Annex D Fulford and Heslington Ward

D1	Location: The Outgang, Heslington																		
1	Background information (reason for proposal)																		
	<p>Problems associated with vehicles parking on grass verges and obstructing access.</p> <p>This is a narrow access road serving the sports field/pavilion, two residential properties and agricultural access to fields.</p> <p>The parking problems are likely to be intermittent for events at the sports field/pavilion.</p> <p>Enforcement would be “hot-line” only.</p> <p>When parking partially on the verge occurs it would reduce the carriageway width to one vehicle and potentially obstruct access for wider agricultural vehicles.</p>																		
2	Proposed amendment to the Traffic Regulation Order																		
	<p>Waiting restrictions for the full length of adopted highway as requested</p>

<table><tr> <td rowspan="4">  </td> <td colspan="2"> <small>© Crown copyright. All rights reserved. Licence No. 10003</small> </td> <td>SCALE</td> <td>1 : 500</td> </tr><tr> <td colspan="2">The Outgang, Heslington</td> <td>DATE</td> <td>19/08/2015</td> </tr></table>

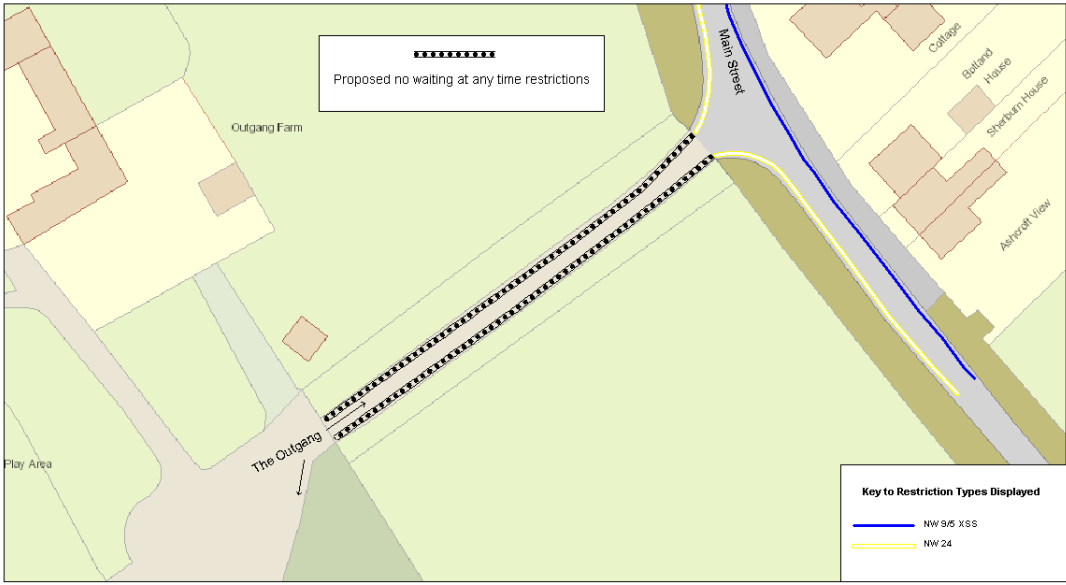
<p>We support the objective of preventing parking on The Outgang on the following proviso: Our preferred solution to the visually intrusive double yellow lines is: Reinstate the verges to their original height of 330mm and position a number of timber posts along the verges to prevent parking. There is insufficient car parking available at the sports ground. Alternative sites should be provided with clear signage directing clients to this area. Removing car parking on the access road will displace the vehicles onto Low Lane which has the potential to cause worse problems, obstruction and safety issues.</p> <p>Parish Council: <i>“The Parish Council are disappointed that further yellow lines are proposed within the Conservation Area and would ask you to look again at this matter.”</i> and <i>“The proliferation of yellow lines are the Parish Council’s concern; The Parish Council could identify some alternatives, such as high kerbs...”</i></p>	<p>It is the responsibility of the sports club to source and sign any additional parking amenity.</p> <p>There are existing double yellow lines on one side of the carriageway on Low Lane which should alleviate some obstruction issues in this area should cars displace.</p> <p>The problem is intermittent and only occurs when events are held in the Sports pavilion.</p> <p>Highway maintenance have told us that there is no funding available for raising/edging the verges and installation of bollards. However, this could be investigated further if Ward funding or Parish Council funding was offered.</p>

<p>4 Options Available</p>	
	<p>a) Implement the proposal as advertised. This is not the recommended option because local opinion (Parish Council) are concerned about the additional waiting restrictions in a conservation area.</p> <p>b) Take no further action at this time. This is the recommended option because it would give the Ward Council and Parish Council time to explore other options with Highway Infrastructure.</p>
<p>5 Recommendation Option (b): Take no further action at this time.</p>
